## **Addendum #1 – June 1, 2023**

#### **Section 22-00100-04-SM**

Summary of Changes: Added 3 patch locations on 700E Rd, 1200N Rd and 1100E Rd to the bid documents.

**PROPOSED STRUCTURE OVERLAYS FOR  
SN 053-3026, 053-3027, 053-3028 & 053-3029**

1. COVER SHEET, STANDARDS, & SUMMARY OF QUANTITIES
2. PROPOSED TYPICAL CROSS SECTION SN 053-3026
3. PROPOSED TYPICAL CROSS SECTION SN 053-3027, 053-3028 & 053-3029

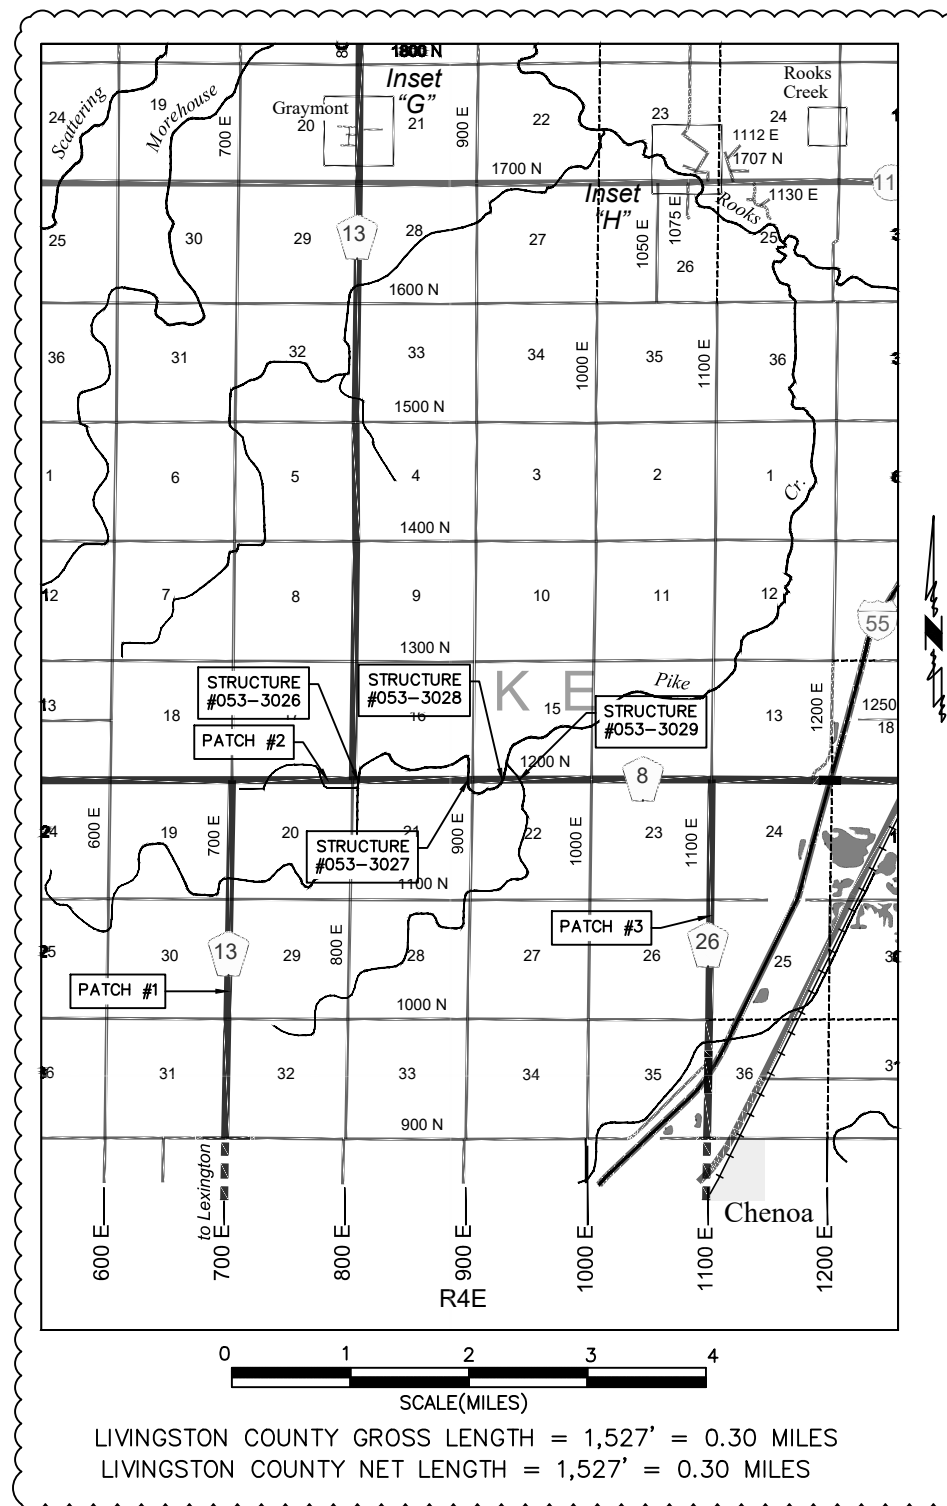
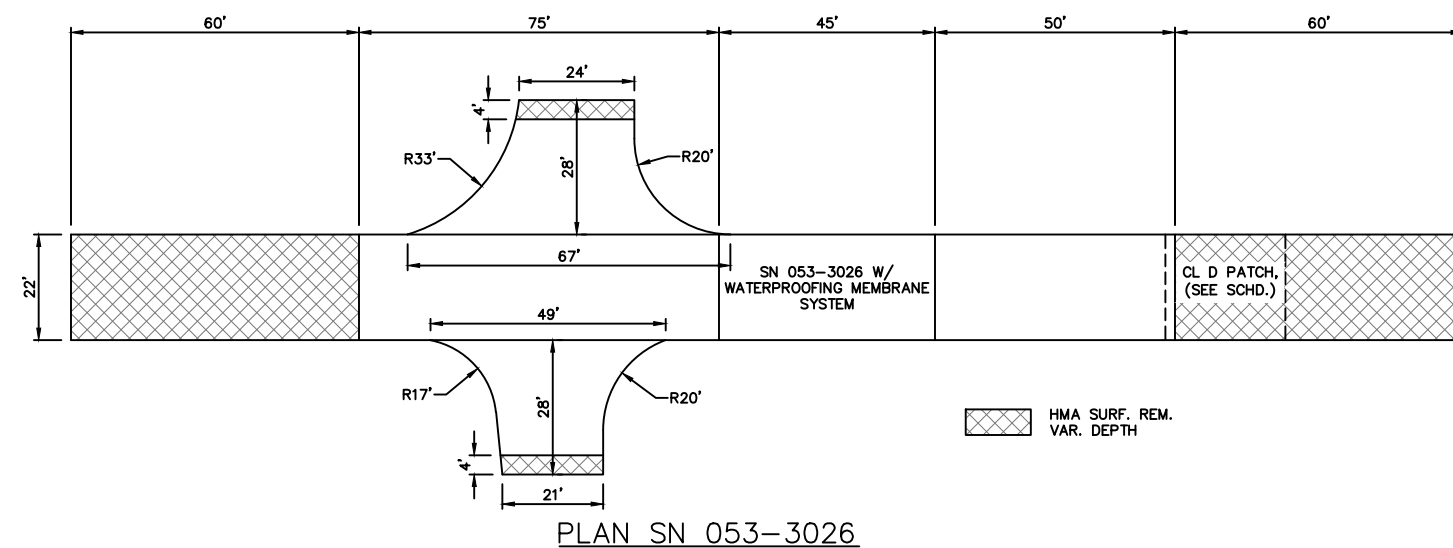
1. Replace Page 1 of the plans with the attached Page 1.
2. Replace Page 2 of the plans with the attached Page 2.
3. Replace the Schedule of Prices on Page 7 or the proposal with the attached Schedule of Prices.  
(Note: The electronic Schedule of Prices should be used)

**LIVINGSTON COUNTY:** THIS PROJECT CONSISTS OF OVERLAYING EXISTING STRUCTURES ALONG CH 8 (1200N RD). INCLUDES THE OVERLAY OF STRUCTURES 053-3026, 053-3027, 053-3028 & 053-3029 LOCATED ALONG 1200N RD BETWEEN 800E RD AND 1000E RD & THREE HMA PATCHES ON 700E, 1200N & 1100E.
